Consultation overview document

The Hinkley Point C (Nuclear Generating Station) Order 2013

Consultation on proposed application by NNB Generation Company (HPC) Limited to remove the requirement to install an acoustic fish deterrent at Hinkley Point C

Figure 3.3: Potential siting of AFD structures as part of the LVSE intake head

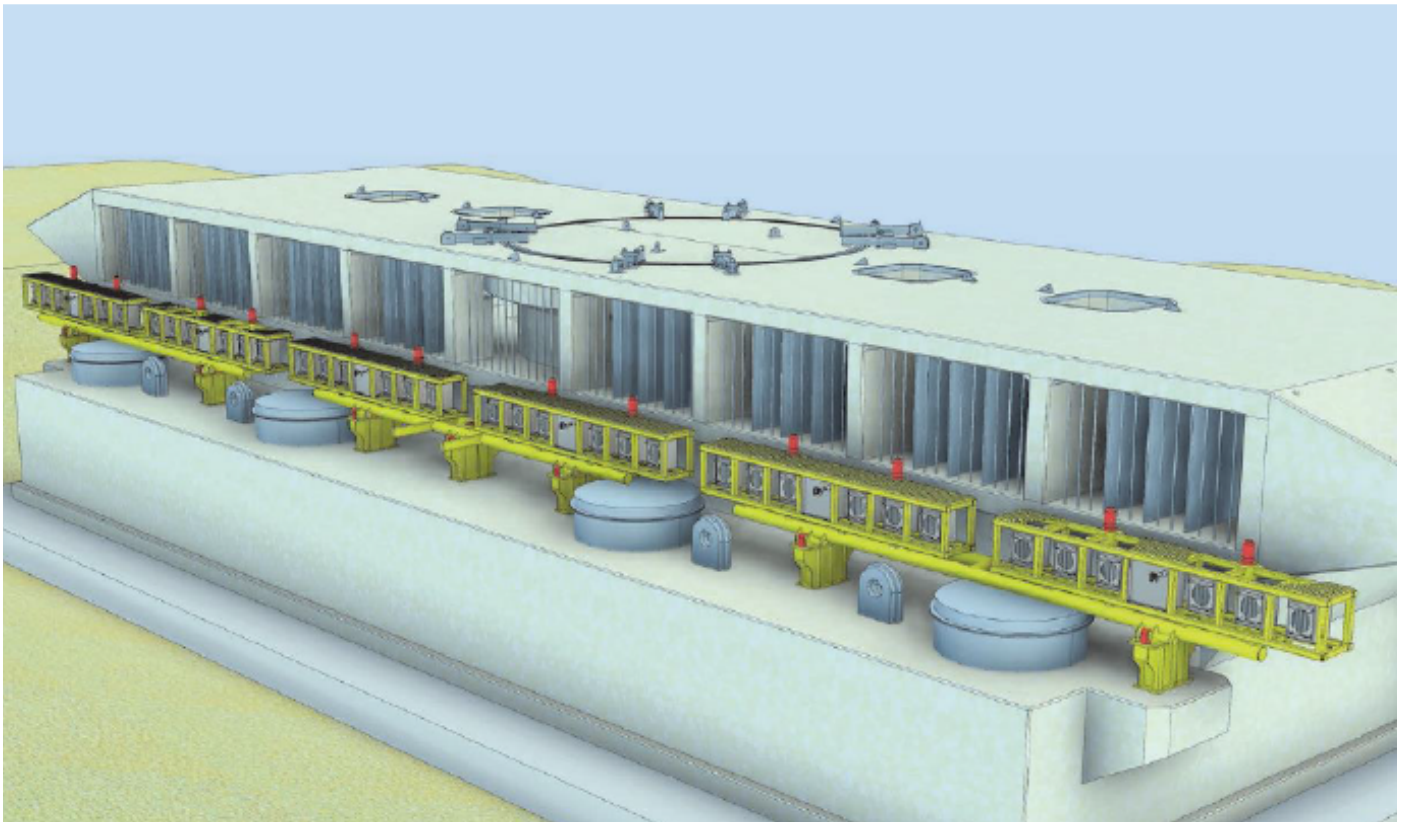
3.5.4 Reflecting the complexity of these considerations, the optimum design identified by NNB would require a total of 288 underwater sound projectors (72 projectors per intake head), located along the sides of each intake head.

3.5.5 The installation of permanent structures with rails and/or lifting frames to raise the sound projectors out of the water for maintenance was considered but concluded not to be practical. The sound projectors would therefore need to be fixed to sea-bed mounted piled structures and installed/recovered (for maintenance) in clusters by divers.

3.5.6 Figure 3.3 illustrates the optimum design identified by NNB (AFD system infrastructure shown in yellow). The process undertaken to identify this optimum design is described in more detail in the AFD Optioneering Report.

3.6.2 The removal of the requirement to install an AFD system is the subject of this consultation.
